Office Action Summary

10/823,410

HADDOCK, ROBERT M.M.

DETAILED ACTION

Figure 31 from Haddock

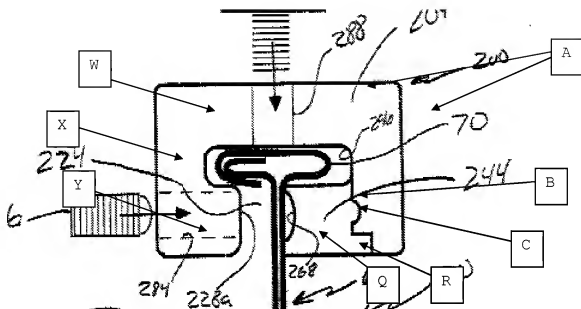
Claim 31: Haddock discloses a clamp and panel assembly comprising a panel assembly comprising a plurality of interconnected panels with base sections (Fig. 7c: 58) and ribs (proximate 66), and a clamp (200) mounted on the first rib comprising a first clamping member (portion 204) that engages a first sidewall of the rib (it engages the rib by being in proximity to the rib) and extends beyond the first rib (it

extends beyond in both vertical and horizontal directions) the portion has a cantilever (see "A" from attached Fig. 7c below,) an attachment mounting fastener (292) threadably engaged with said mounting flange, a second clamping member (244) that engages the second sidewall of the first rib (as shown) the second clamping member extends beyond the first rib (in a horizontal direction,) a first end ("B" below) of the second clamping member engages an underside of the mounting flange a first fastener (276) located beyond the first rib and associated with both first and second clamping members (it is associated with the two members in that as it is tightened, it draws the members together) and the first fastener lacks a nut.

Claim 38: Haddock discloses a clamp and panel assembly comprising a panel assembly (Fig. 7c: 58) comprising a plurality of interconnected panels having base sections (58) and ribs (66) the ribs have sidewalls (proximate 66) that extend away from the base section, the sidewall has indentations (portion 66 and proximate 62 are indentations compared to portion proximate 70) and a clamp (200) mounted on a rib comprising a first clamping member (204) that engages a first sidewall of the first rib where the clamping member comprises a mounting flange ("A" above) in the form of a cantilever, an attachment member (292) threadably engaged with the mounting flange, a second clamping

member (244) engaging the second sidewall of the first rib and extends beyond the first rib (in a horizontal direction), the second clamping member is a separate piece from the first clamping member and has a first end ("B" above) that engages an underside of the mounting flange and a second head (268) disposed in the second indentation and a first fastener (276) located beyond the first rib (horizontally) associated with the first and second clamping members (see above for explanation of "associated") and is in addition to the attachment mounting fastener, wherein activation of the first fastener causes the clamping members to exert at least an inwardly-directed force on the first rib.

Claim 45: the underside of the mounting flange of the first clamping member has a recess ("C" above) that is concave and arcuately shaped, and the first end of the second clamping member is convex and arcuately shaped (proximate "C") and is disposed in the recess of the first clamping member where activation of the first member causes the second member to move relative to the first clamping member at least generally about the first projection (activation of member 276 would cause this action.)

sections (Fig. 7c: 58) and ribs (66), and a clamp (200) mounted on a first rib comprising a first clamping member (204) engaging a first sidewall of a first rib that is disposed beyond the rib (in both a horizontal and vertical direction) the first section comprises a mounting flange in the form of a cantilever ("A" above), a mounting fastener (292) threadably engaged with the flange, a second clamping member (244) that engages a second sidewall of a rib and extends beyond the rib (horizontally) and has a first end ("B" above) that engages an underside of the mounting flange of the first clamping member, and a first fastener (276) located beyond the first rib and associated with the first and second clamping and is in addition to the attachment mounting fastener, wherein activation of the first fastener retains the clamping members on the rib.

Claim 51: the first section ("W" above) of the first clamping member is parallel with the base.

Figure 15 from Dressler

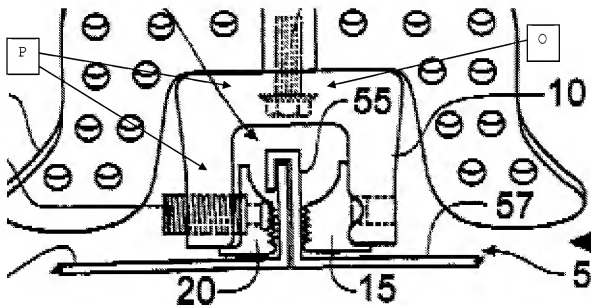
Claim 49: Dressler discloses a clamp and panel assembly (see Fig. 15) having a panel assembly (57) comprising a plurality of interconnected panels having base sections and ribs, and a clamp (10) mounted on a rib comprising a first

clamping member (10) that engages a first sidewall of said first rib (see above for definition of "engaging") and comprises a first section (see "O" from attached Fig. 15 from Dressler, below) that is disposed beyond the first rib, where in the first section comprises a mounting flange in the form of a cantilever ("P" below), an attachment mounting fastener (50) threadably engaged with the mounting flange, and a second clamping member (20) that engages a second sidewall of a rib and extends beyond the rib (both vertically and horizontally) and comprises a first end that engages an underside of the mounting flange of the first clamping member, and a first fastener (60) located beyond the first rib associated with the first and second clamping members, and in addition to the attachment mounting fastener, and activation of the first fastener retains the first and second clamping members on the first rib.

Claim 60: the second clamping member has a non-threaded bore (Dressler, see Fig. 9: 23), and the other member has a threaded bore (Fig. 5: 21) and the fastener (60) extends through the non-threaded bore and into the threaded bore (as shown in Fig. 15.)
